**MAJOR MODIFICATION**

**OPERABLE UNIT 1: 881 HILLSIDE AREA**

**CORRECTIVE ACTION DECISION/RECORD**

**Responses to the Environmental Protection Agency Comments on the  
Draft Proposed Major Modification to the CAD/ROD for Operable Unit 1**

Figure 1. OU 1 Collection Well Trichloroethene Concentrations and Projection.

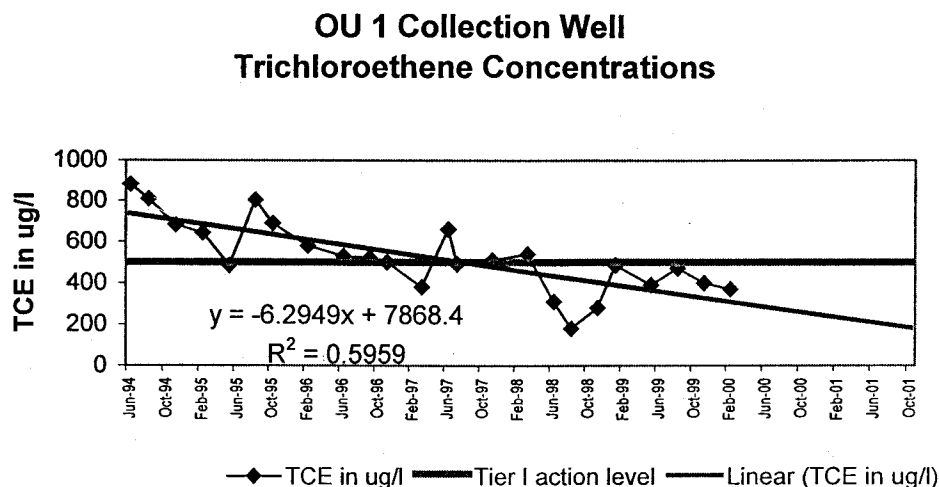
1. **Since a declining trend in concentration, as shown by a linear regression, is the justification for modifying the original remedy, the same justification should be used for discontinuing operation of the Collection Well. Cessation of pumping and treating should occur only if this linear regression of TCE concentrations continues to decline for at least one year following CAD/ROD approval.**

Concentrations of TCE in the Collection Well have remained below the Tier I action level of 500 ug/L since June 1998, and continue to show a declining trend as indicated on the attached concentration plot (also included in the CAD/ROD). Operation of the Collection Well will continue for one year after signing the Major Modification to the OU1 CAD/ROD. After that time, if the declining trend for TCE concentrations in the well continue to be below the Tier I action level (500 ug/L), then pumping and treating of groundwater will be discontinued. The Collection Well will then be designated as a Plume Definition Well and monitored consistent with the RFETS Integrated Monitoring Plan.
